GRO ARCHITECTS, PLLC

PROJECT: **803 S URBAN RENEWAL LLC**  
 BLOCK 645, LOT 12  
 PROPOSED MIXED USE BUILDING  
 CITY OF PLAINFIELD, UNION COUNTY, NEW JERSEY

# DESIGN KEY POINTS- SUMMARY OF UPDATES

### CLARIFICATION OF SF PER "FLOOR AREA" DEFINITION "FROM EXTERIOR FACES OF EXTERIOR WALLS"

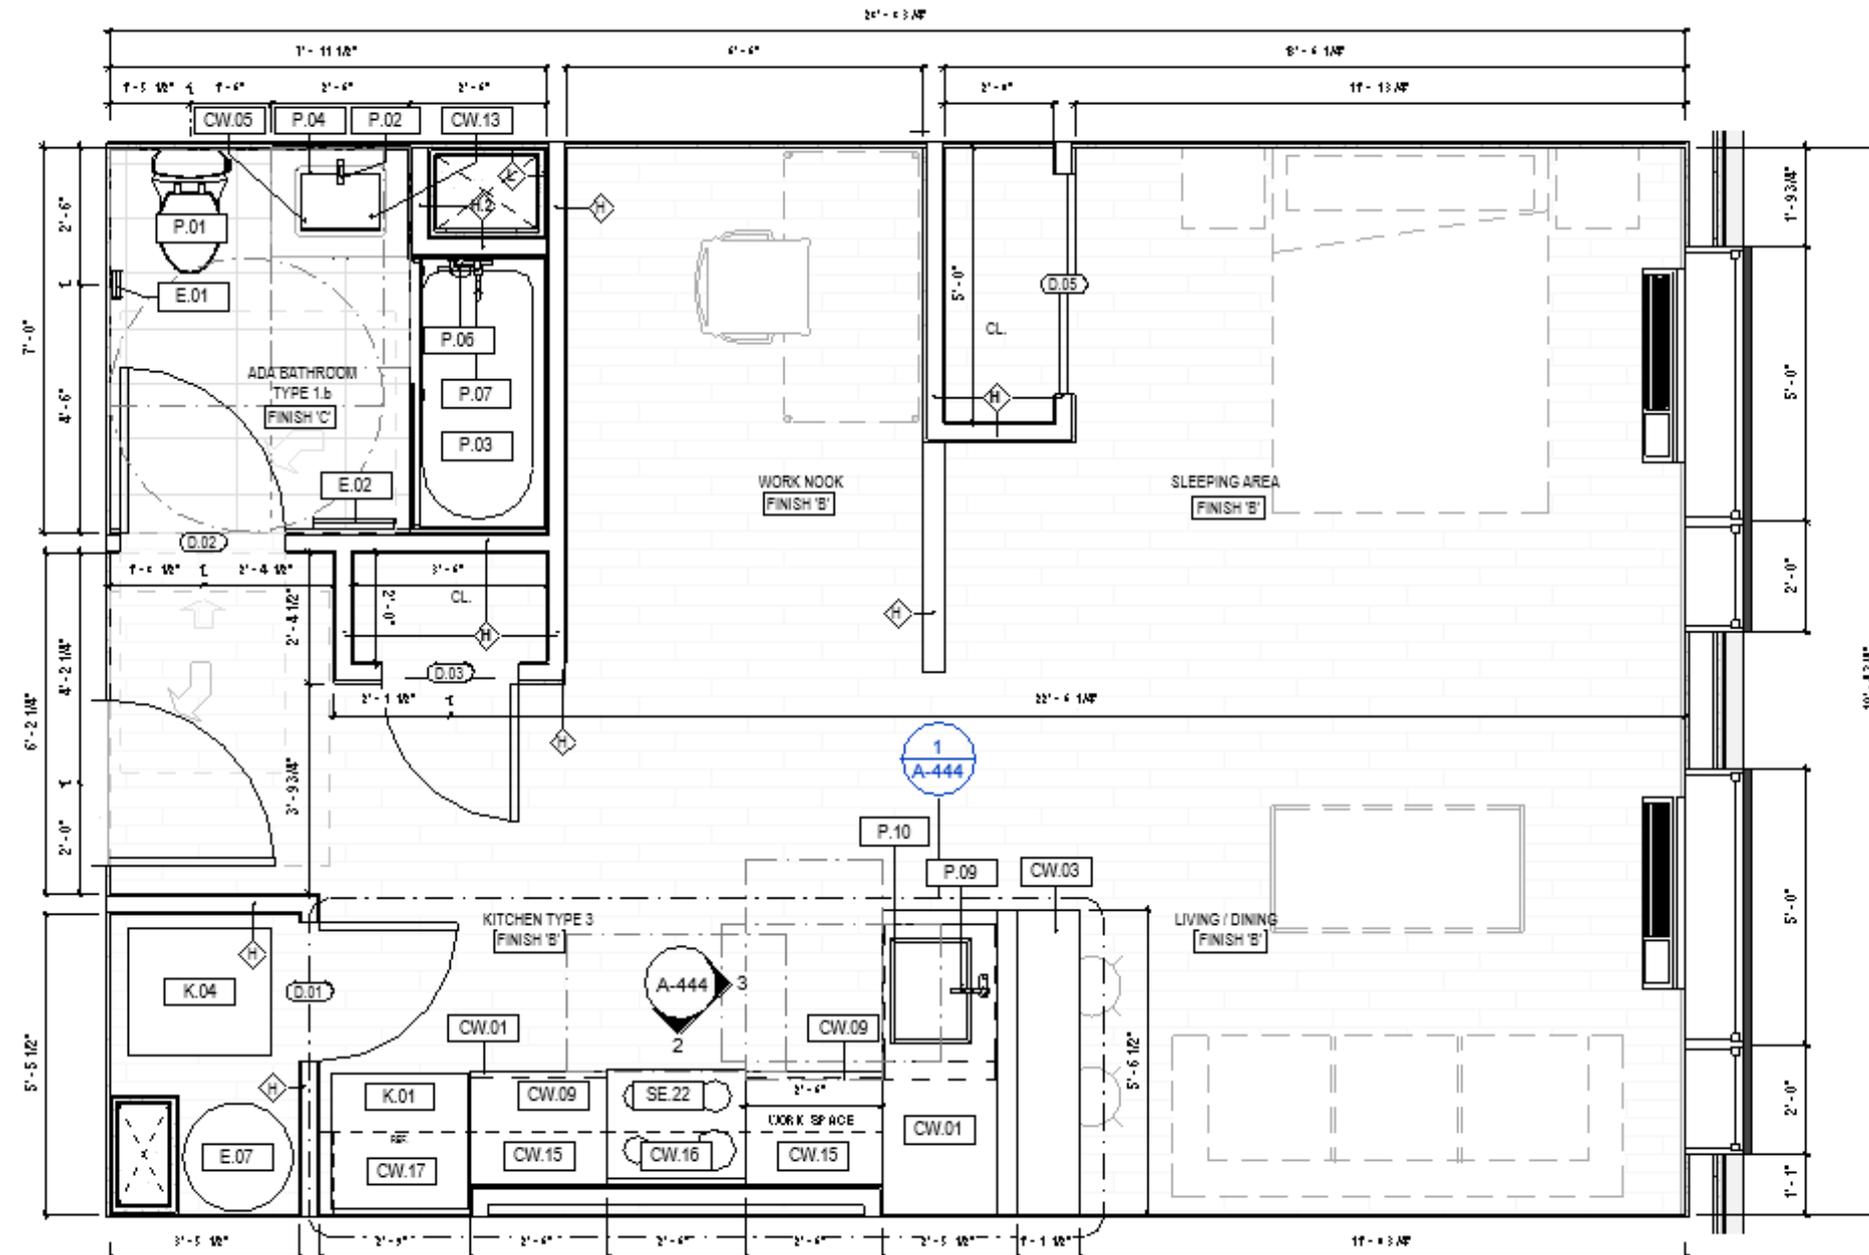
UNIT TYPE SCHEDULE				
UNIT TYPE	UNIT AREA	NO. BEDROOMS	NO. IN BUILDING	TOTAL AREA
UNIT TYPE A.1	739 SF	1 BR	23	16991
UNIT TYPE A.2	758 SF	1 BR	1	758
UNIT TYPE A.3	778 SF	1 BR	3	2335
UNIT TYPE A.4	750 SF	1 BR	3	2249
UNIT TYPE A.5	746 SF	1 BR	9	6713
UNIT TYPE B.1	1073 SF	2 BR	2	2147
UNIT TYPE B.2	1087 SF	2 BR	4	4348
UNIT TYPE B.3	1129 SF	2 BR	7	7902
UNIT TYPE B.4	1110 SF	2 BR	3	3330
UNIT TYPE B.5	1082 SF	2 BR	3	3247
UNIT TYPE B.6	1073 SF	2 BR	6	6440
UNIT TYPE C.1	800 SF	1 BR	2	1600
UNIT TYPE C.2	800 SF	1 BR	6	4800
UNIT TYPE D	585 SF	1 BR	7	4095
UNIT TYPE E.1	895 SF	2 BR	2	1791
UNIT TYPE E.2	895 SF	2 BR	2	1791
UNIT TYPE F	1129 SF	2 BR	4	4516
UNIT TYPE G	1083 SF	2 BR	3	3249
UNIT TYPE H	1175 SF	2 BR	1	1175
UNIT TYPE I.1	867 SF	1 BR	2	1734
UNIT TYPE I.2	867 SF	1 BR	6	5201
UNIT TYPE J	703 SF	1 BR	1	703
UNIT TYPE K	879 SF	1 BR	2	1758
UNIT TYPE L	765 SF	1 BR	2	1530
Grand total			104	90401

UNIT TYPE SCHEDULE				
UNIT TYPE	UNIT AREA	NO. BEDROOMS	NO. IN BUILDING	TOTAL AREA
UNIT TYPE A.1	767 SF	1 BR	23	17641
UNIT TYPE A.2	758 SF	1 BR	1	758
UNIT TYPE A.3	778 SF	1 BR	3	2335
UNIT TYPE A.4	750 SF	1 BR	3	2249
UNIT TYPE A.5	767 SF	1 BR	9	6905
UNIT TYPE B.1	1073 SF	2 BR	2	2147
UNIT TYPE B.2	1087 SF	2 BR	4	4348
UNIT TYPE B.3	1129 SF	2 BR	7	7902
UNIT TYPE B.4	1110 SF	2 BR	3	3330
UNIT TYPE B.5	1082 SF	2 BR	3	3247
UNIT TYPE B.6	1073 SF	2 BR	6	6440
UNIT TYPE C.1	800 SF	1 BR	2	1600
UNIT TYPE C.2	800 SF	1 BR	6	4800
UNIT TYPE D	585 SF	1 BR	7	4094
UNIT TYPE E.1	1009 SF	2 BR	1	1009
UNIT TYPE E.2	1000 SF	2 BR	3	3001
UNIT TYPE F	1129 SF	2 BR	4	4516
UNIT TYPE G	1083 SF	2 BR	3	3249
UNIT TYPE H	1175 SF	2 BR	1	1175
UNIT TYPE I.1	867 SF	1 BR	2	1734
UNIT TYPE I.2	867 SF	1 BR	6	5201
UNIT TYPE J	751 SF	1 BR	1	751
UNIT TYPE K	879 SF	1 BR	2	1758
UNIT TYPE L	765 SF	1 BR	2	1530
Grand total			104	91719
